**ADDENDUM #1**  
 June 15, 2023

**TO: ALL Prospective Bidders**  
**PROJECT NAME: GPI Effluent Sewer Realignment**  
**BID REFERENCE #: 91345-004.0**  
**BID DUE/OPENING DATE: Tuesday, June 27, 2023 at 3:30 p.m. Local Time (ET)**

**JONES & HENRY ENGINEERS ADDENDUM  
01**

**GPI EFFLUENT SEWER REALIGNMENT**

BY-PASS VAULT AND MISCELLANEOUS DETAILS

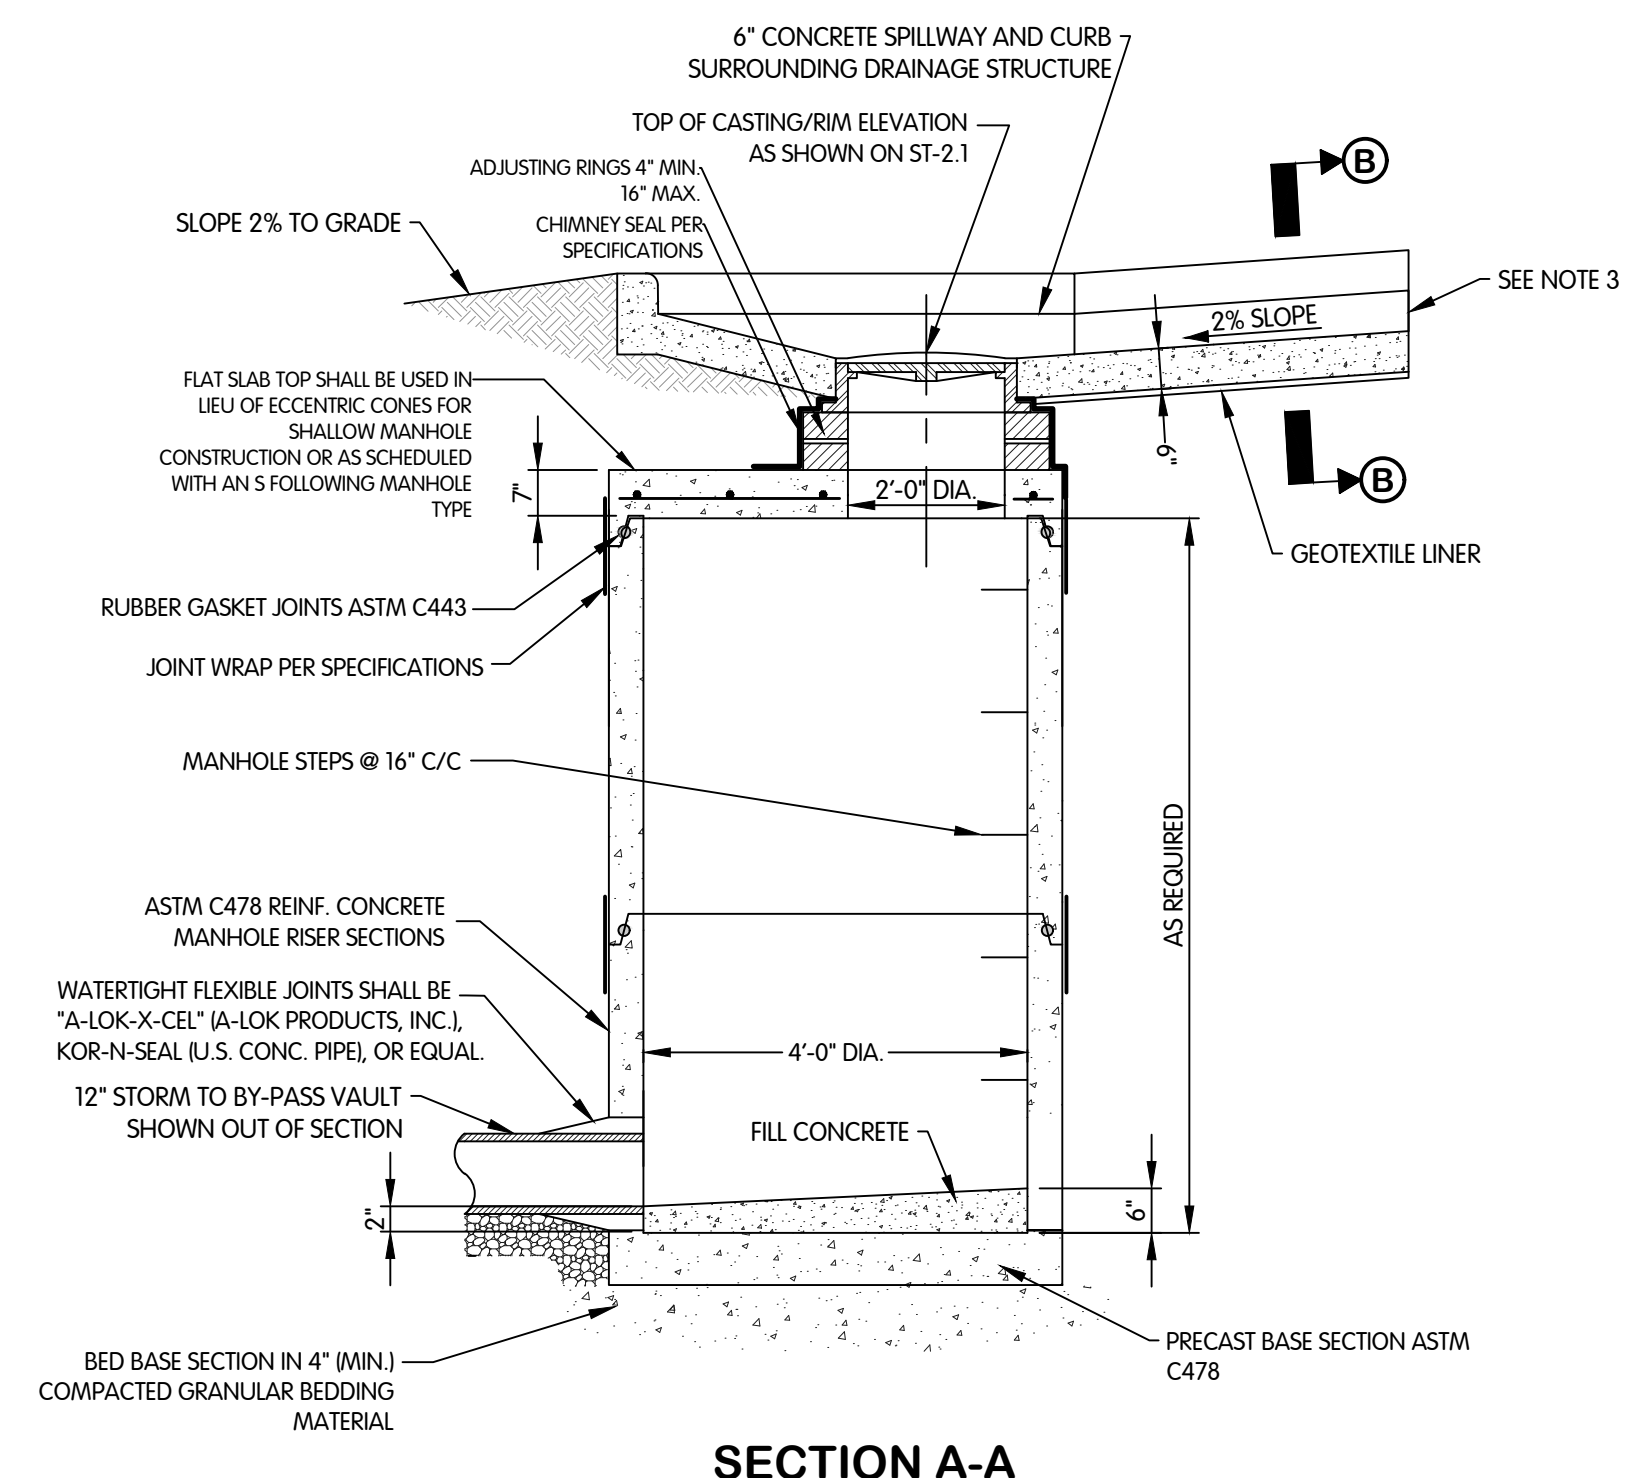
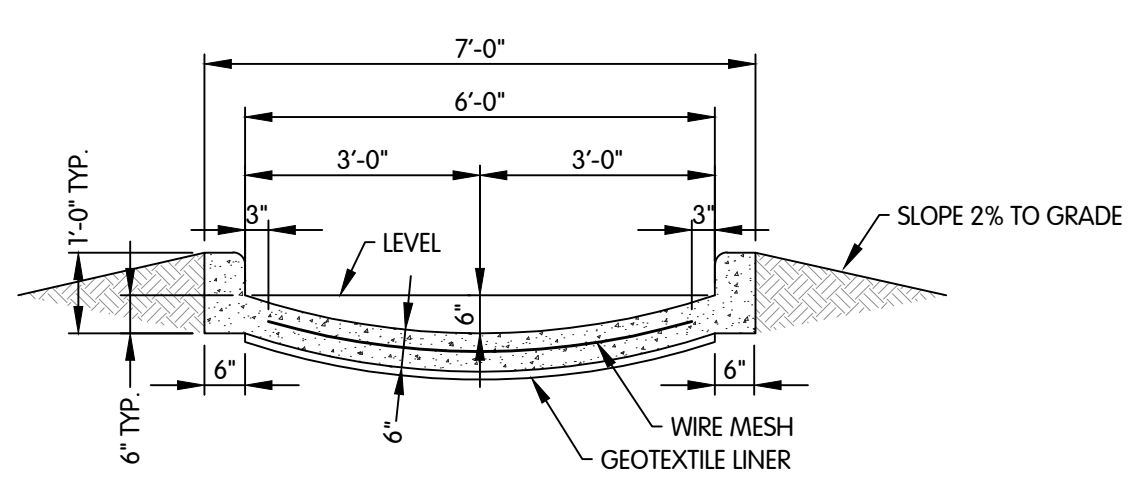
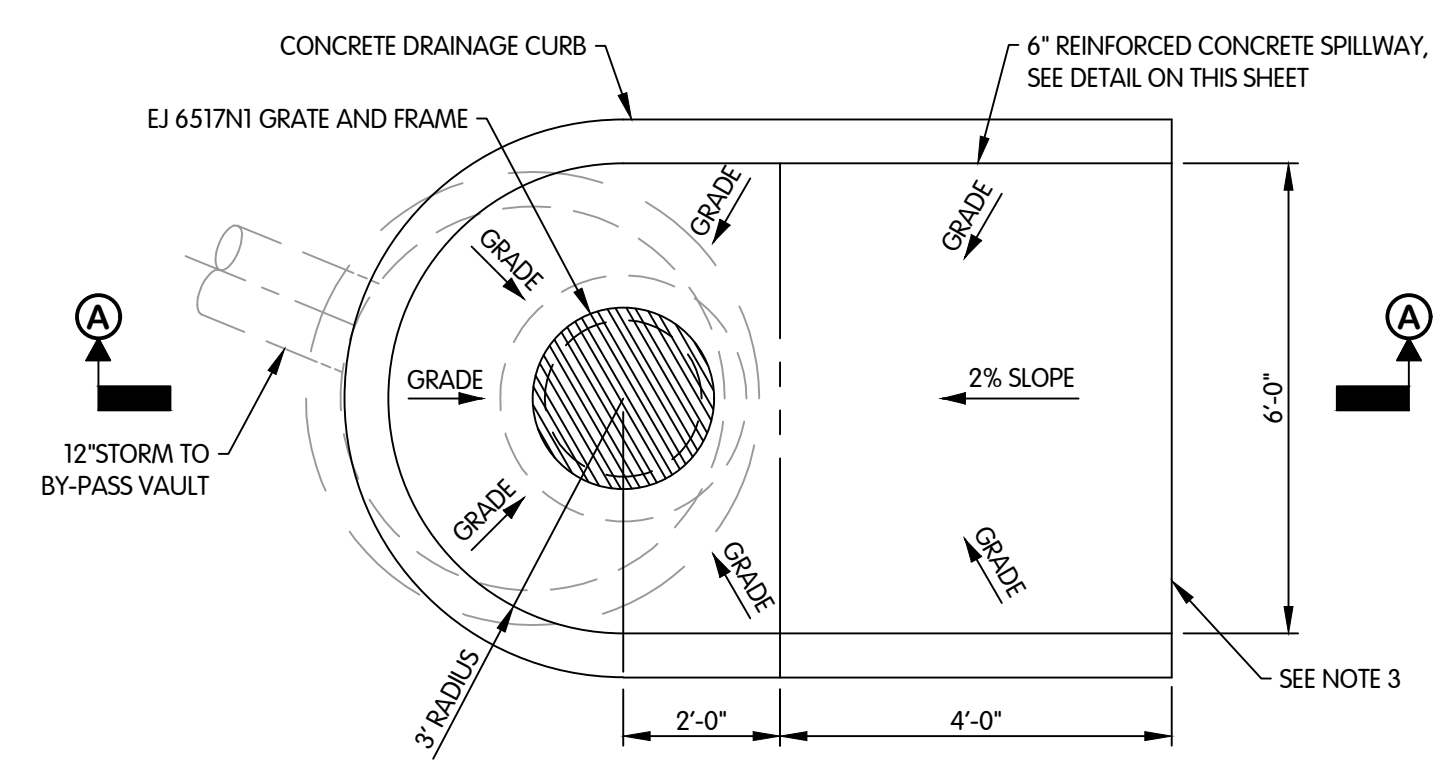
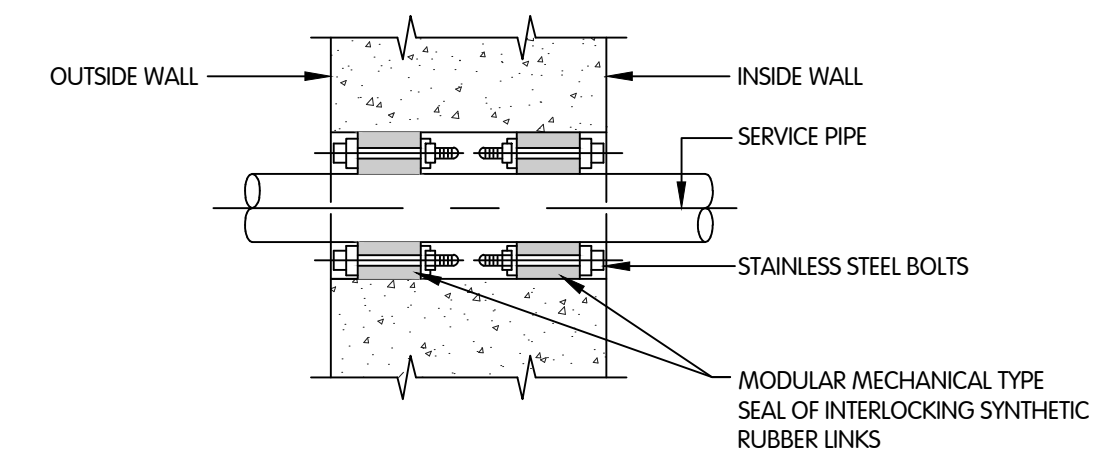
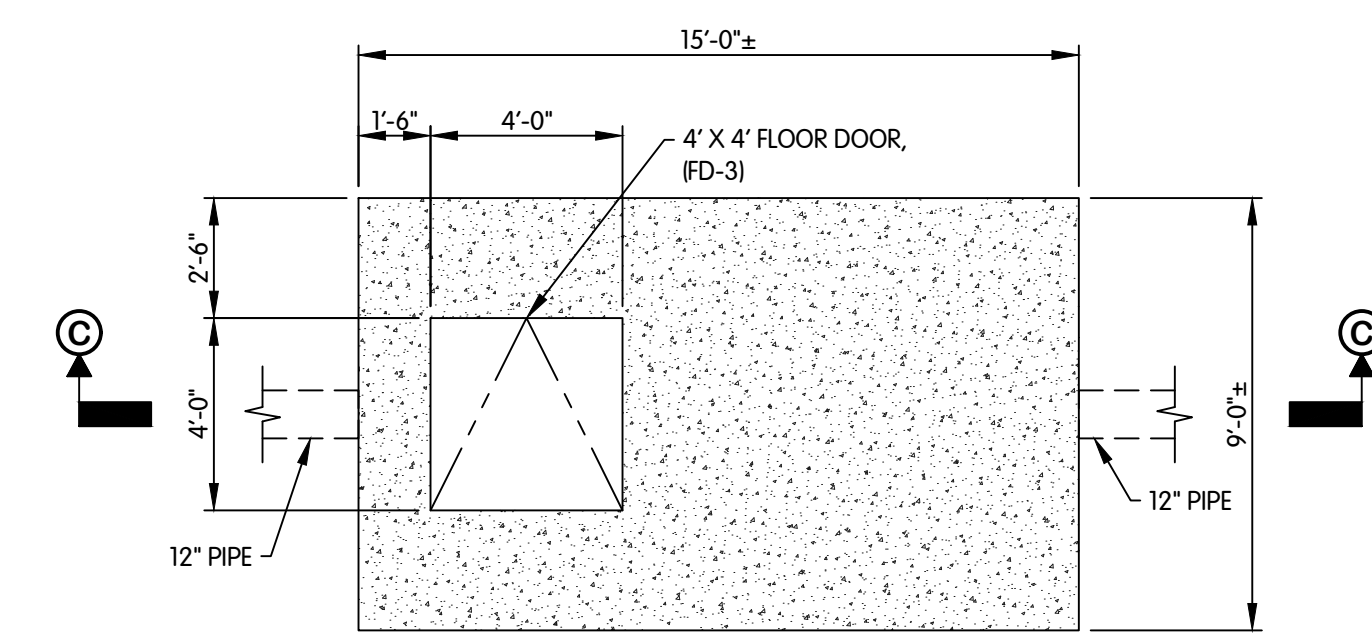
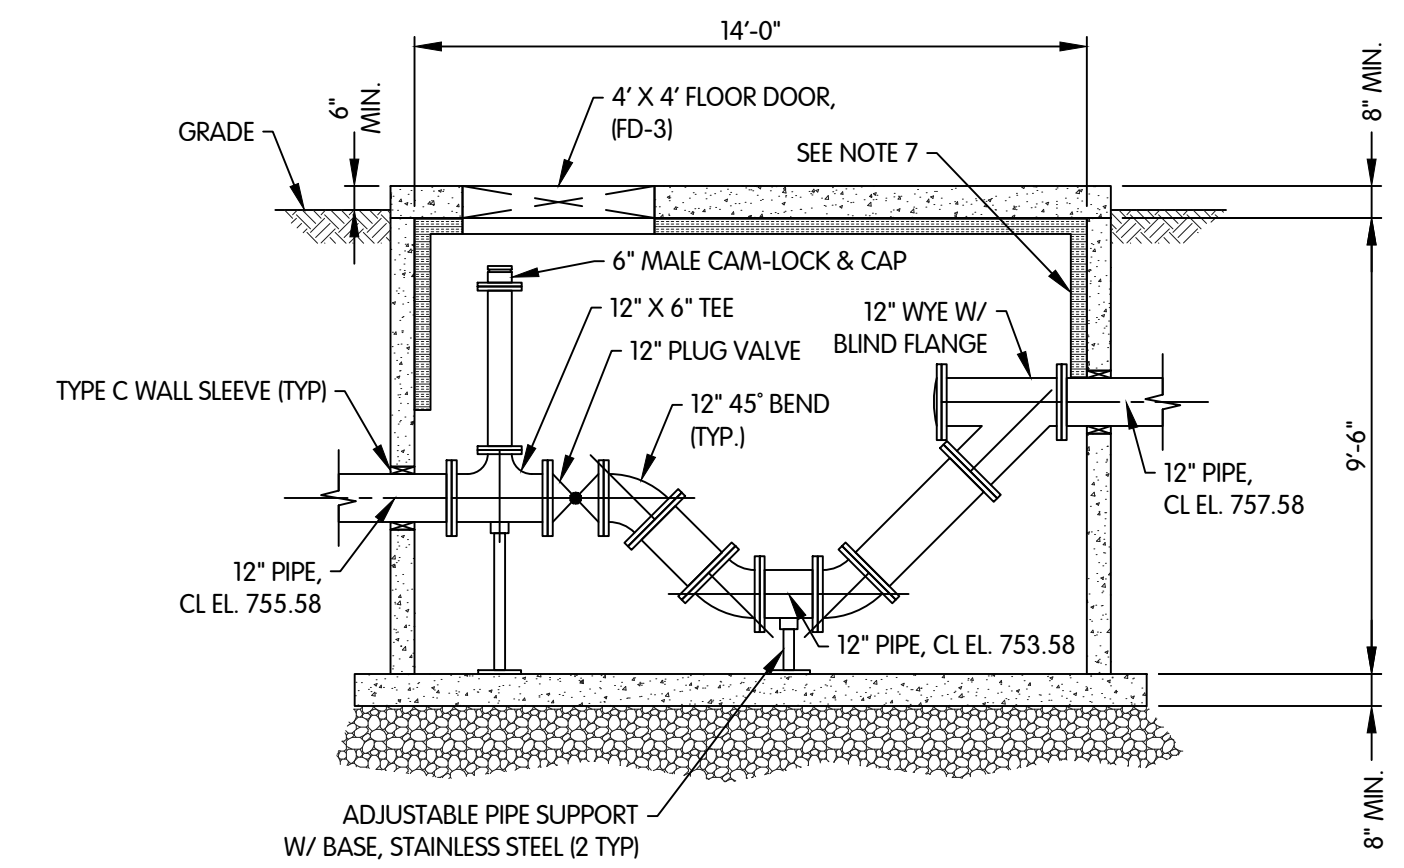
Additional storm sewer work, concrete spillway and By-Pass Vault is included in Addendum 01.

C-2.1, ST-2.1
